From: Baker, Kate H (Swift)
Sent: Sunday, July 25, 2010 9:56 AM
To: Ritchie, Bryan
Subject: RE: ACTION REQUIRED: MC252 Subsurface Technical Memo

From: Ritchie, Bryan
Sent: Friday, July 23, 2010 2:09 PM
To: Baker, Kate H (Swift); Yeilding, Cindy; Thorseth, Jay C; Carragher, Peter D
Cc: Albertin, Martin L.; Bondurant, Charles H; McAughan, Kelly; Nguyen, Binh Van; Scherschel, Craig; Skripnikova, Galina
Subject: ACTION REQUIRED: MC252 Subsurface Technical Memo
Importance: High

ACTION: Please review and reply to me with any comments/edits by noon on Monday 26th July as we have been requested to give an updated version to the investigation team by COB on Monday.

TITLE: Post-Well Subsurface Description of Macondo well (MC 252) v2

Figure 3: M56 Depth Structure Map and Amplitude Map.

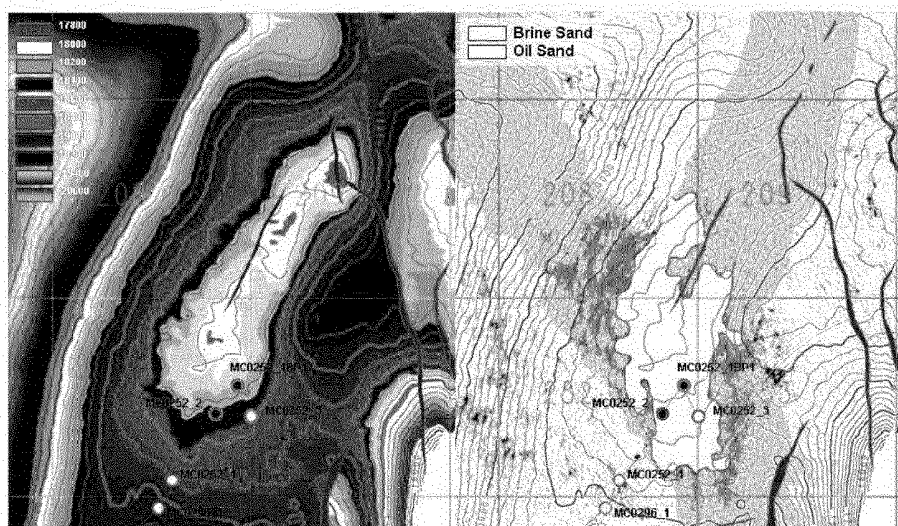
Comment [b3]: Amplitude map needs further clarification. Is this amplitude capable of resolving the individual channels? Is one to infer that everything within the yellow-shaded area is a continuous reservoir sand? I doubt it, but that is surely what the map suggests.

Figure 4: M57 Depth Structure Map and Amplitude Map.

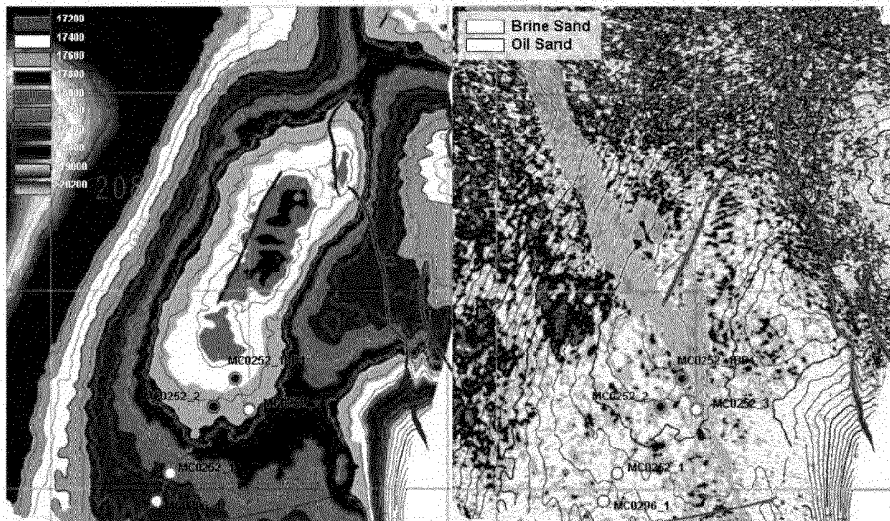
Comment [b5]: The legend on the amplitude map is confusing. Is there an oil sand immediately around the MC252#3? What is the meaning of the green shaded feature? Is all the cyan color brine sand?

Figure 6: M110 Depth Structure Map and Amplitude Map

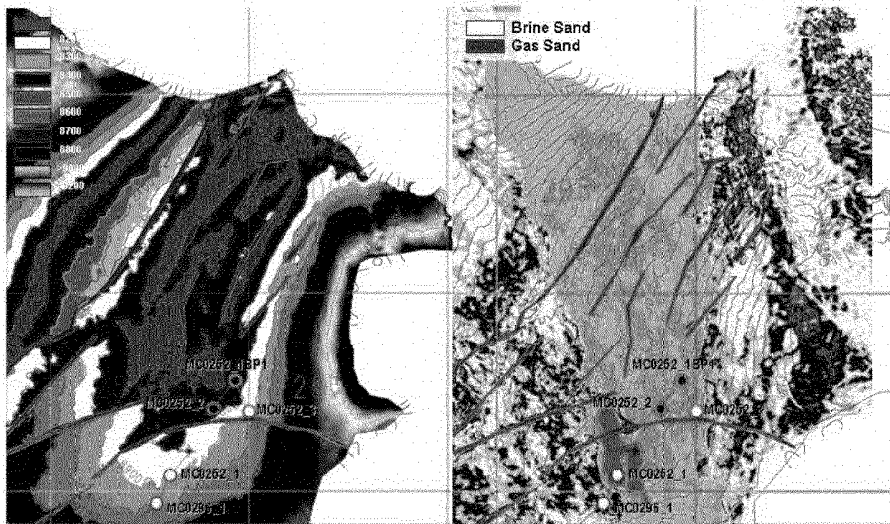
Comment [b6]: The legend on the amplitude map continues to confuse me. Are there gas sands in the NE? What is the meaning of the green shaded feature? Is all the cyan color brine sand? Is the brown around the Rigel field wells supposed to be the color of the legend box labelled "Gas Sand"?

Figure 9: Post-well PPFG interpretation.

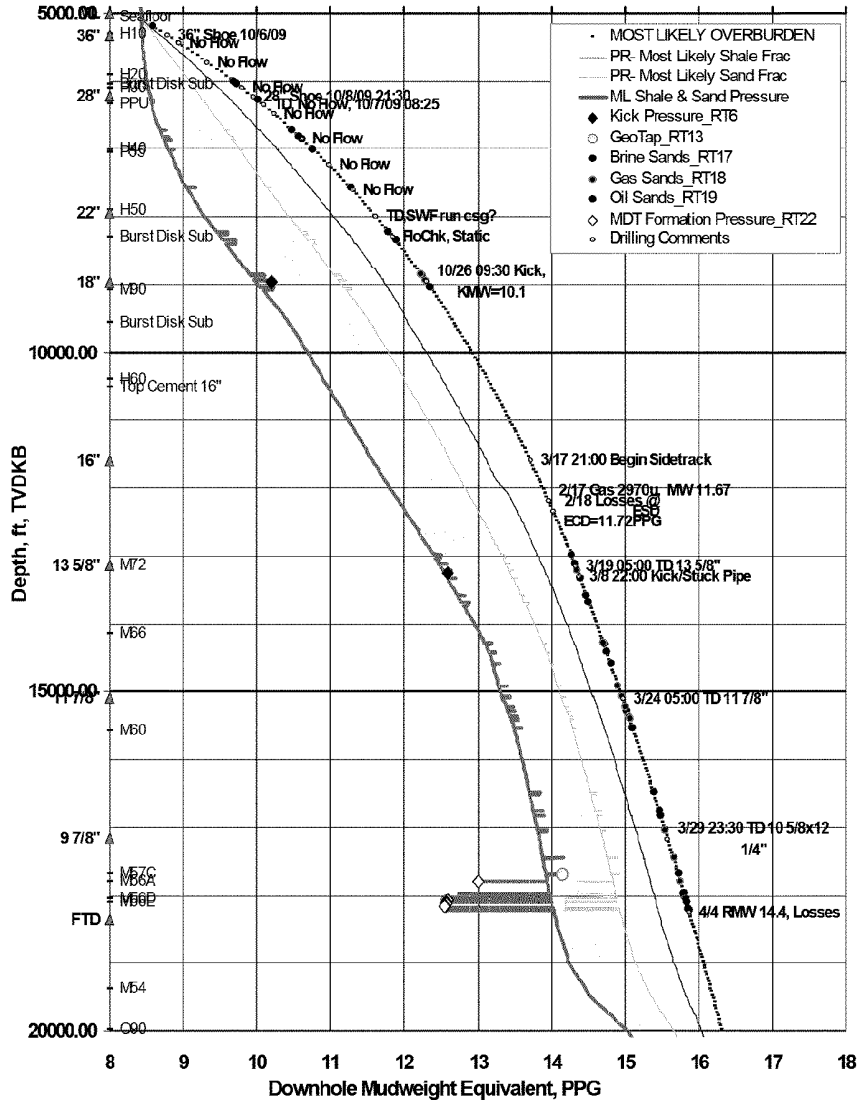
Comment [b10]: Was it really that, or was it setting a shoe in a sand, and thus failing to get an appropriate leak-off? If the PPFG window was tighter, was it outside the predicted envelope, or merely above the Most Likely value? This is a VERY important point, so BP needs to agree what was the cause and write that cause down here

Figure 15: Frequency distribution of Core measured Klinkenberg permeability to air at NCS and Porosity at NCS separately per sands and both sands together.

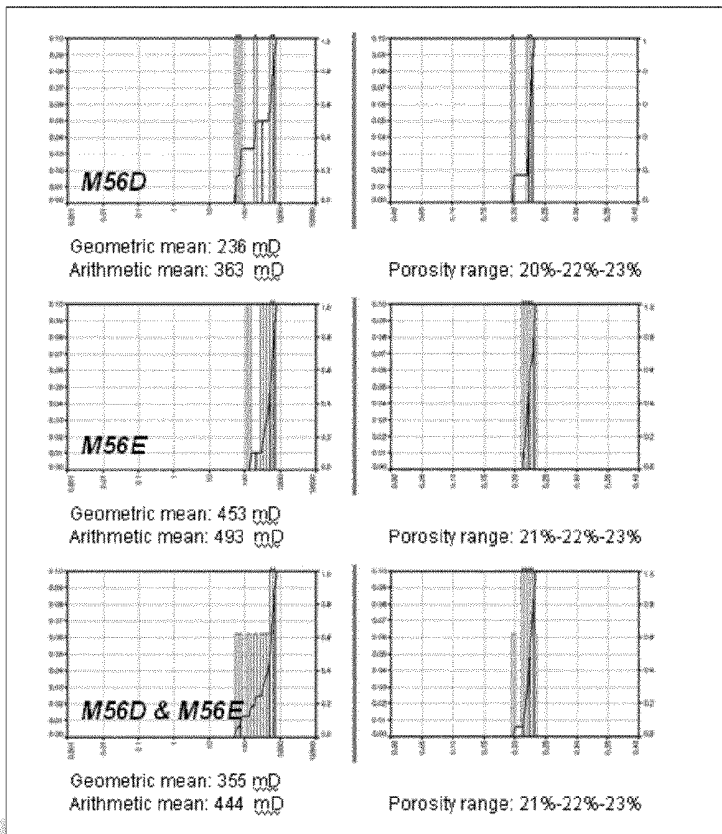
Comment [b18]: I am not sure I understand this figure. Were there a total of 17 samples? Is the histogram a linear representation of the number of samples in each porosity percentile and each 1/10 log permeability decile?

Figure 23: Density Porosity (with uncorrected density input) distribution in M56D sand vs. Core porosity.

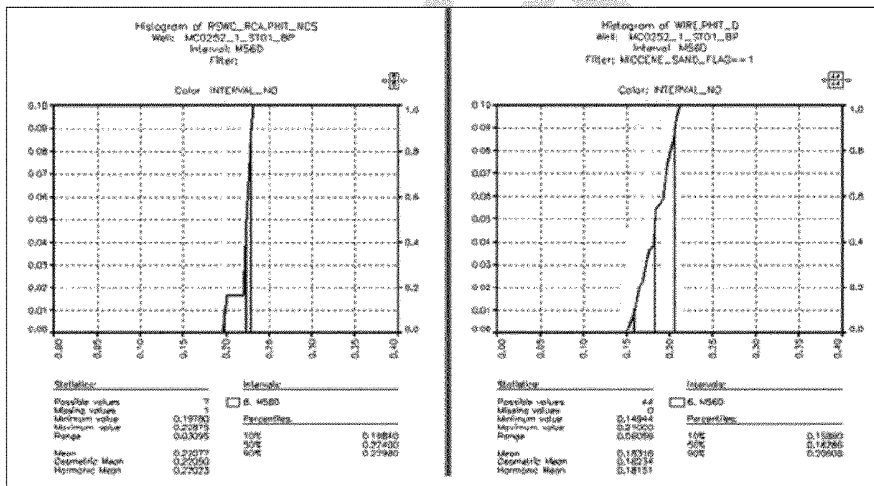
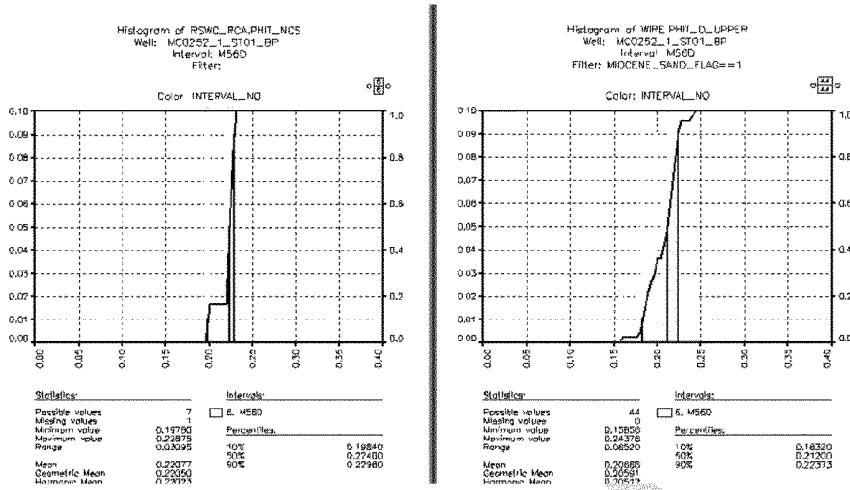
Comment [b22]: IN this and the figure above, what are the vertical red lines? Mean +/- 1 standard deviation? The figure caption for each should make this clear. Same applies to the following figures as well.

Figure 26: Log derived Permeability distribution in M56E sand vs. Core Permeability.

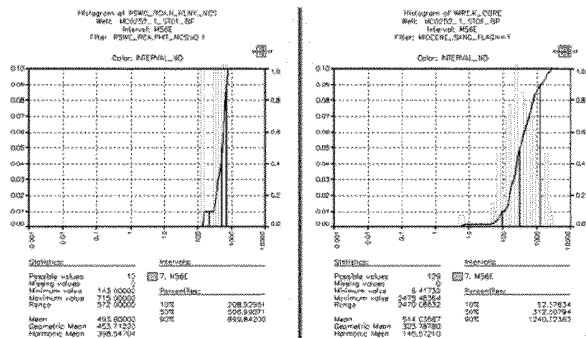
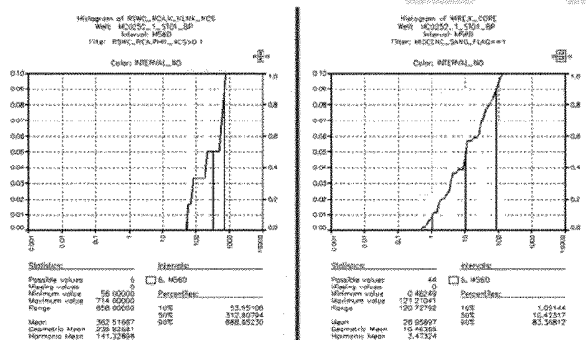
Comment [b25]: Where is the cross-plot of log perm vs core perm with R2 value. That is what you want and basically all you need to affirm the goodness of fit between log and core perm. The rest of this is not really very telling, nor does it strike me as very compelling. Asserted goodness of the match seems highly subjective.

Figure 28: Log derived Permeability distribution in M56D sand vs. Core Permeability. Closer to Core Perm distribution when Density porosity derived with corrected density log input.

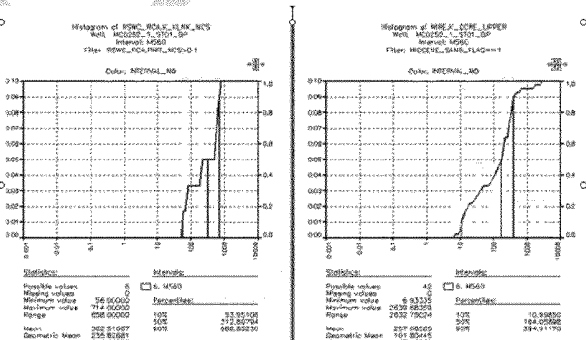
Comment [b26]: This caption and similar are misleading. The data shown are NOT log derived vs core derived permeability. They ARE side-by-side plots of log perm vs frequency and cum frequency. It is unclear which is log and which is core data. I'm betting the stuff on the right is core even though the stuff on the left has CORE in the title, e.g. Fix the captions to reflect what you are displaying or better yet, fix the plots to show log vs core derived perm.

Figure 29: Fluid typing of sands M57B and M56A.

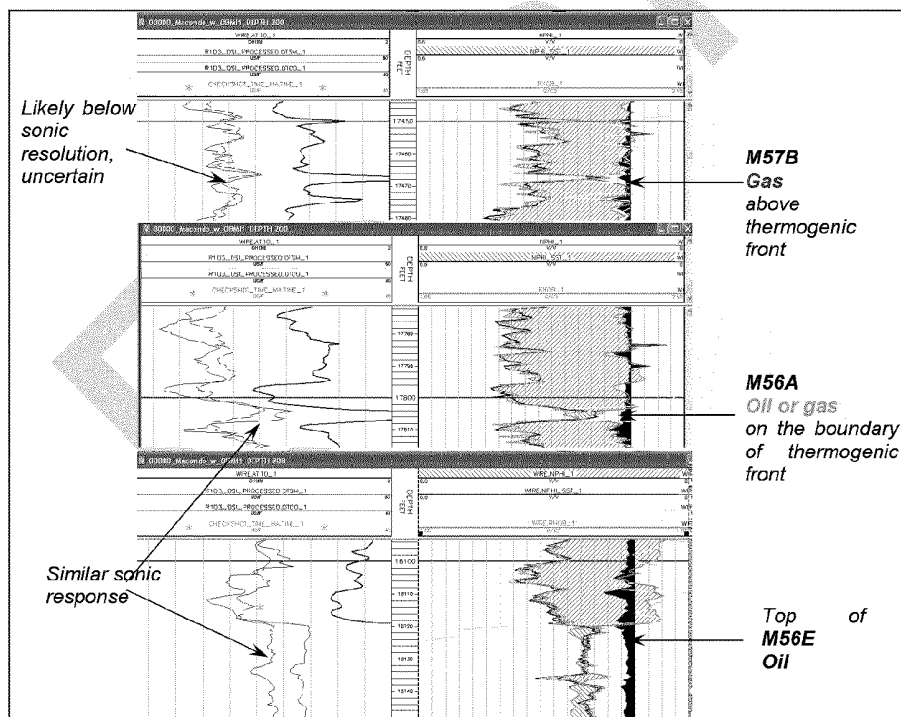
Comment [b27]: What did the mud log show? Any difference in heavies or fluorescence? If there were SWCs taken, any difference in cut?

Comment [b28]: How confidently is the depth/age of the thermogenic front known? What is the presumption about maturation in a downdip source vs being cracked in the currently penetrated location. (Some reference to the section beginning on p37 might help, but that section would have to be beefed up a bit to discuss why the thermogenic front was drawn where it is.)
